# You've Spoken and We've Listened

## Improved Locking Collar Installation

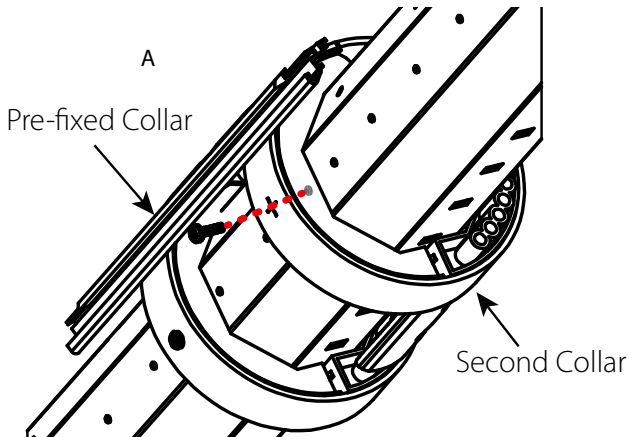
We've take your feedback on board and improved the way that the collars on this product are fixed to the axle, this will ensure a quicker and more precise installation on-site.

The position of the pre-fixed collars has been adjusted so that the second collar in each pair now lines up with the pre-punched holes on the axle (see **Drawing A**).

This means it is no longer necessary to drill a pilot hole when fixing the second collar to the axle.

**IMPORTANT:** When attaching the collars, make sure that the fixing has fully engaged with the pre-punched hole on the axle (see **Drawing B**).

The collar should fit tightly to the axle. Ensure that there is:

- No space between the inside of the collar and the axle.
- No movement from side-to-side.
